TECHNICAL SERVICE BULLETIN

TB08-113 R

TO: RESIDENTAL AND MAYTAG DISTRIBUTORS
FROM: TECHNICAL SERVICE DEPARTMENT
DATE: APRIL 4, 2008
RE: C-6 LIQUID LINE STUB

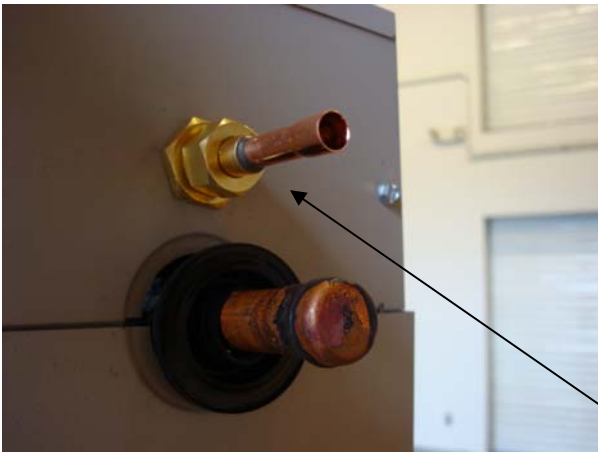
With the introduction of the new C-6 coil, we would like to explain the new liquid line set up. The New C-6 coil will come charged with nitrogen. There is fitting on the liquid line with a black cap and under the cap is Schrader valve. That fitting should be removed and replaced with the liquid line stub attached to the coil.

For verification that the coil does not have a leak, the Technician should depress the Schrader valve under the Black cap to release the pressure in the coil.

When the pressure is released from the coil, slide the nut (664387) over the brazing stub (664378) and braze the line set the stub (**remember to slide the nut on the stub before brazing**).

Liquid line Brazing stub (664378)

Fitting with black cap and Schrader valve

Liquid line brazing stub (664378) with nut (664387)
